City of Richmond
Urban Design Committee

Re: VCU Health Pedestrian Bridge Encroachment
HKS Project Number 21168.000

Thank you for your comments regarding the review of the VCU Health Pedestrian Bridge Encroachment. We would like to offer the following responses to your comments received during the February 2020 UDC meeting.

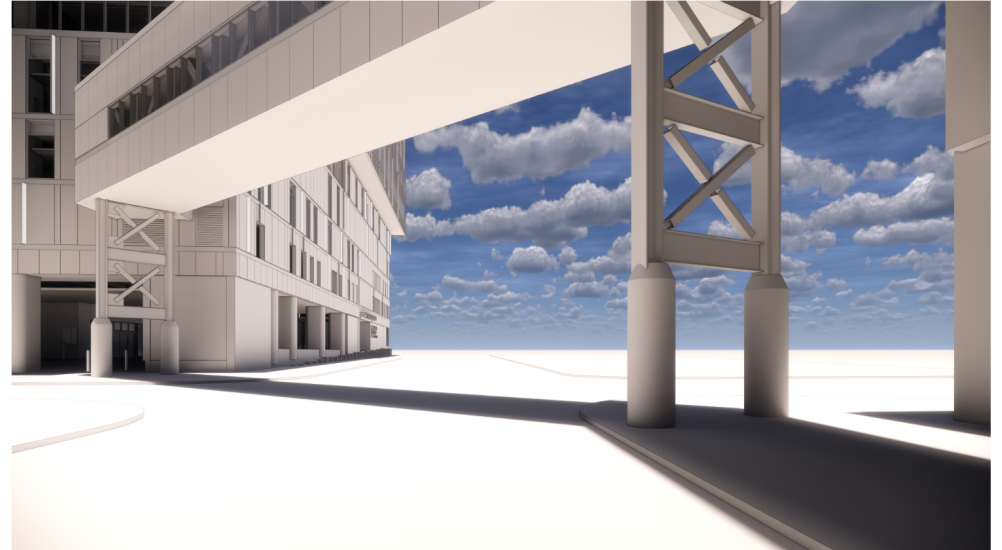
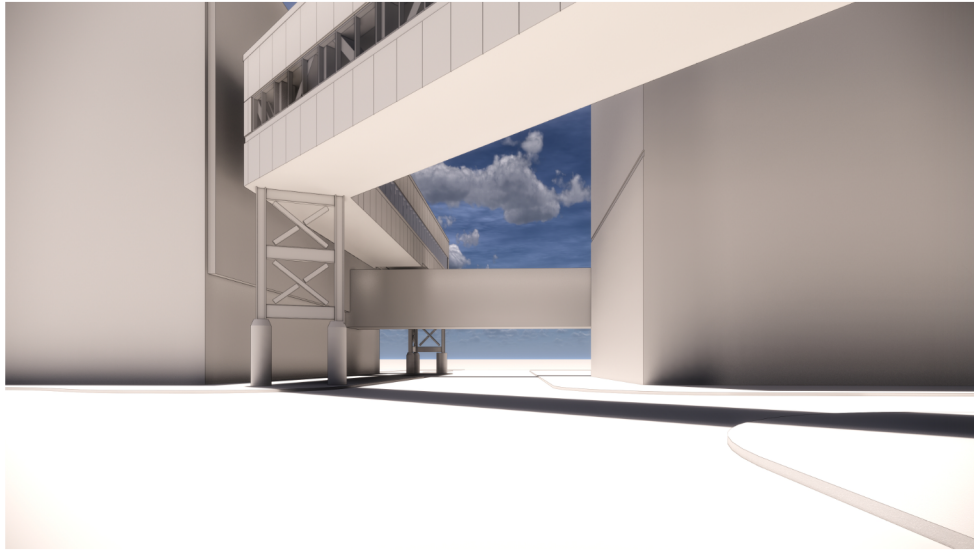
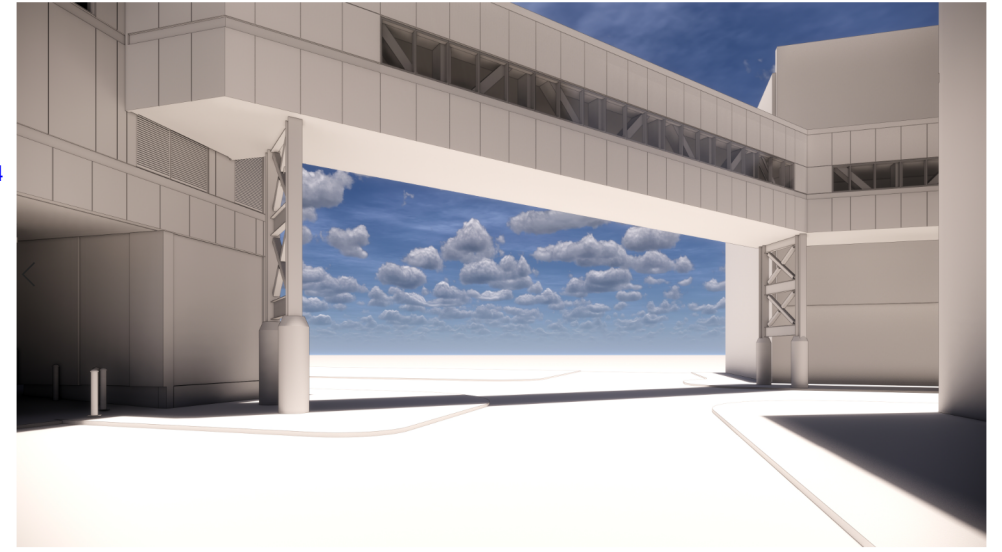
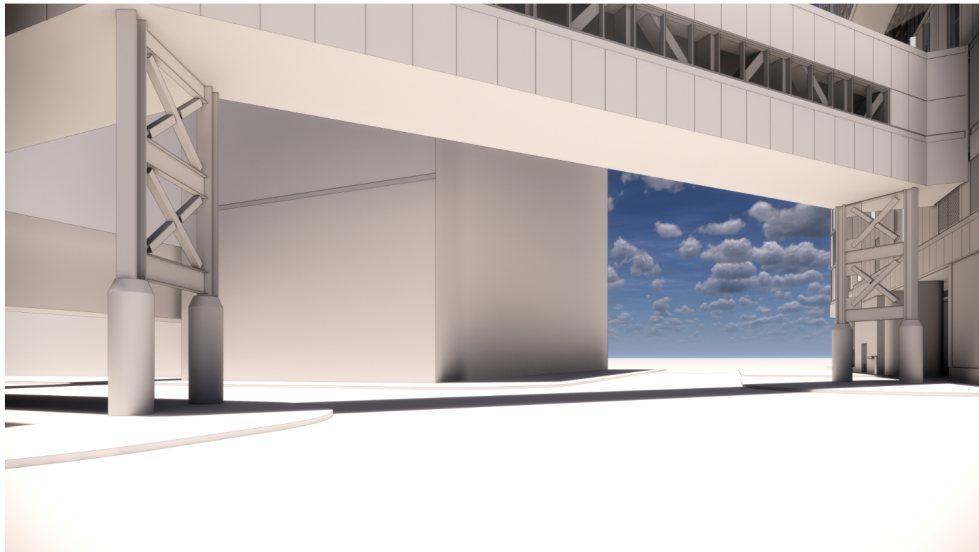
Pedestrian bridge aesthetic design, including comments regarding the expanse of blank, undifferentiated wall, unifying design of support columns and streetscape.

HKS RESPONSE: Graphic renderings have been revised to show a simplification of exterior metal panel colors and arrangement. A single metal panel color was selected for the bridge that is consistent with the metal panel colors to be used on the new Children's Hospital and will integrate seamlessly into the greater exterior fabric of existing buildings. The renderings also reflect a linear expanse of ribbon windows allowing for continuous views from interior and helping to break up the exterior façade. The windows help balance transparency and patient privacy along the path of travel.

Bridge soffit lighting has also been added to the assist with lighting the pedestrian path at night. The areas of soffit lighting are concentrated over the sidewalks to allow for light where it is most needed and allow for ease of future maintenance. Additional white box renderings have been added to show each corner of Marshall and 11th Street. The attached QR code can also be used to obtain a VR, white box, view of this intersection.

The columns have been revised to reduce the amount of column cover, allowing the structure to be exposed at the top and a circular concrete form (similar to the existing CHoR Pavilion) to be used on the lower portion to provide the needed stability for a vehicle impact barrier.

SHEET TITLE
**SIGNAGE & STRIPING
PLAN**

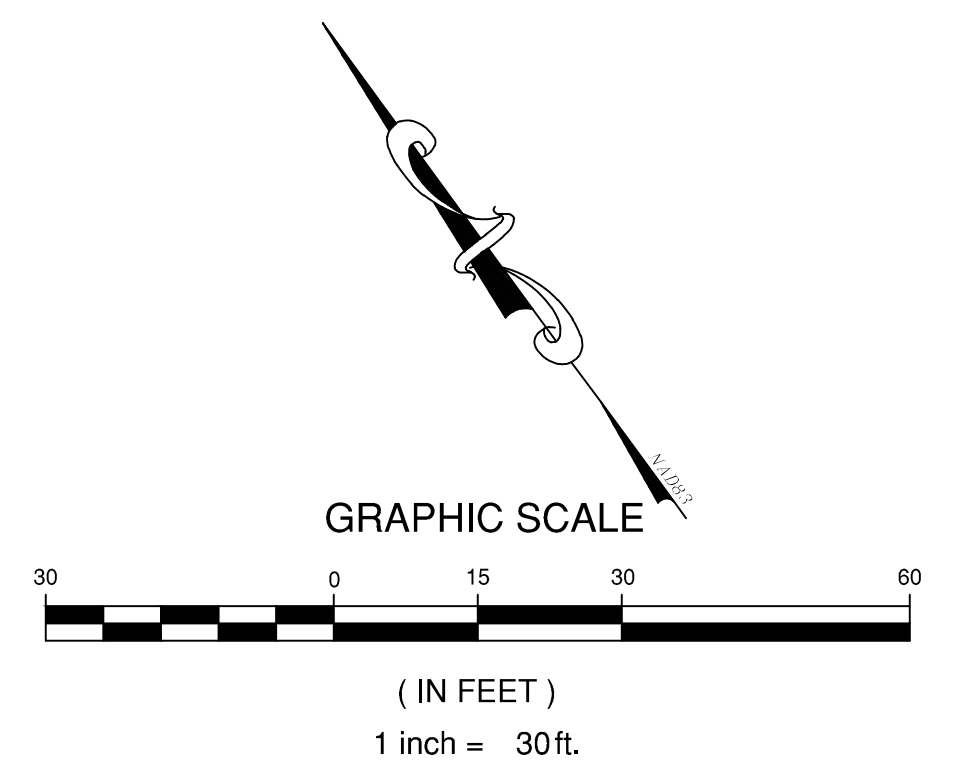
1.	CITY DPW COMMENT	9/28/20
----	------------------	---------

Revised landscape and civil drawings have been submitted to reflect City of Richmond comments and UDC comments regarding the streetscape.
